10 Mb/s Single Twisted Pair Ethernet

10BASE-T1L AWGN Noise Test

Steffen Graber
Pepperl+Fuchs

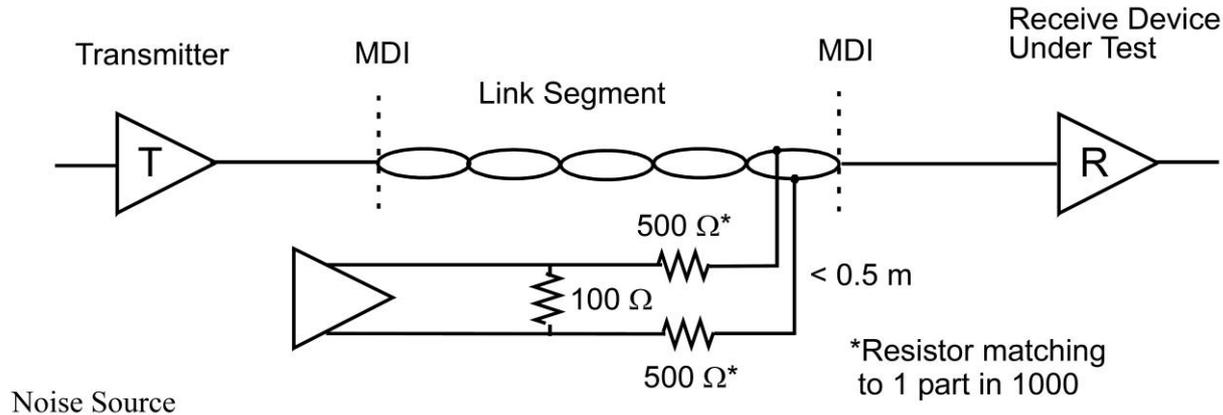
- In Clause 146.5.5.3 (alien crosstalk noise rejection) of the actual PMA specification the AWGN noise level is defined to be -106 dBm/Hz with a bandwidth of 10 MHz using the following test setup:

- As the alien crosstalk (particularly the NEXT) is not influenced by the insertion loss of the victim's link segment or the victim's transmit level, the alien noise level should be kept independent from the victim's insertion loss and transmit level.
- Nevertheless the insertion loss level at which the DUT has to pass the noise test may be dependent on the transmit level of the DUT.
- Therefore the intention is to keep the noise test level the same for the 1.0 V_{pp} mode and the 2.4 V_{pp} mode of the PHY and to adjust the insertion loss limit of the link segment for the 1.0 V_{pp} transmit level.
- Assuming that the same cable and connectors are being used, the different maximum possible insertion loss will lead to a different maximum link segment length.

Transmit, Receive and Noise PSDs

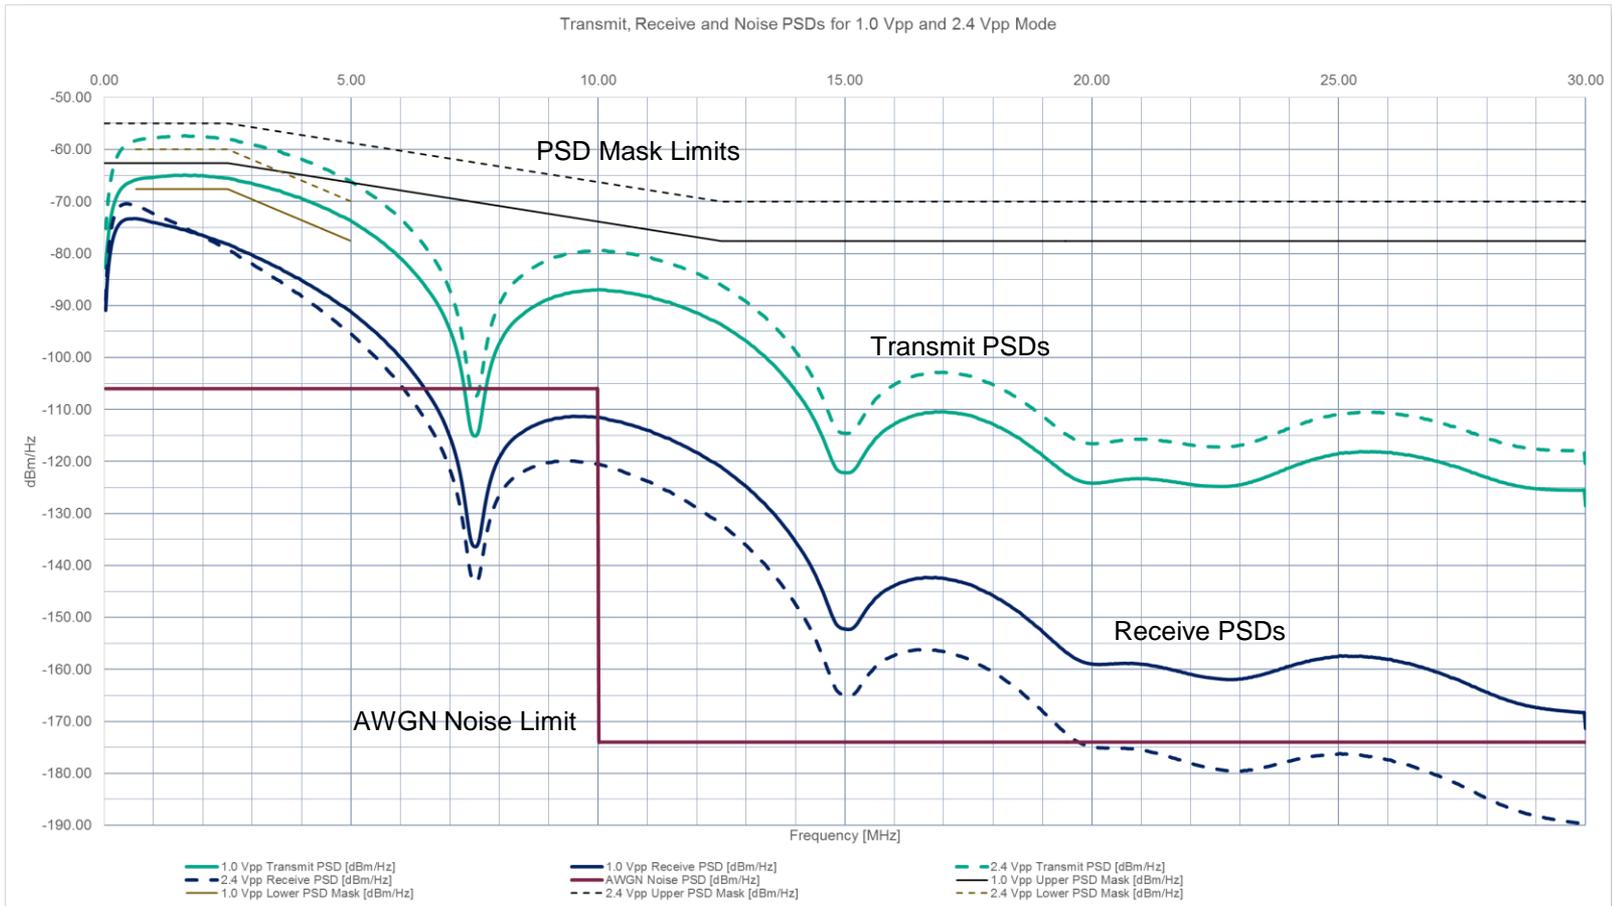
- Using a transmit level of 1.0 V_{pp} instead of 2.4 V_{pp} leads to a reduction in the transmit PSD of 7.6 dB.
- To allow a similar alien noise tolerance for the 1.0 V_{pp} transmit mode compared to the 2.4 V_{pp} transmit mode, the insertion loss of the link segment needs to be reduced.
- Calculating the insertion loss according to the IL limits specified in 802.3cg D1.2 (using the mean square pulse loss, which can be approximately calculated at ½ Nyquist frequency or 1.875 MHz) leads to:

- Reducing the insertion loss limit by 7.6 dB and calculating the resulting link segment length leads to:

$$\frac{18.8 \text{ dB} - 7.6 \text{ dB} - 10 \cdot 0.02 \cdot \sqrt{1.875 \text{ MHz}}}{1.23 \cdot \sqrt{1.875 \text{ MHz}} + 0.01 \cdot 1.875 \text{ MHz} + \frac{0.2}{\sqrt{1.875 \text{ MHz}}}} \cdot 100 \text{ m} = 590 \text{ m}$$

- Therefore the suggestion is to add an additional insertion loss limit for the 1.0 V_{pp} transmit mode in the following way to Clause 146.7.1.1:

- The green curves show the transmit PSDs (solid: 1.0 V_{pp} mode, dashed: 2.4 V_{pp} mode).
- The blue curves show the PSDs at the receiver side after running over the link segment with the frequency dependent insertion loss (solid: 1.0 V_{pp} mode - IL limit as defined on previous page, dashed: 2.4 V_{pp} mode - IL limit as defined in 802.3cg D1.2).
- The red curve shows the AWGN noise limit.

$$IL[dB] = 5.9 \cdot \left(1.23 \cdot \sqrt{f} + 0.01 \cdot f + \frac{0.2}{\sqrt{f}} \right) + 10 \cdot 0.02 \cdot \sqrt{f} \text{ with } 0.1 \text{ MHz} \leq f \leq 20 \text{ MHz}$$
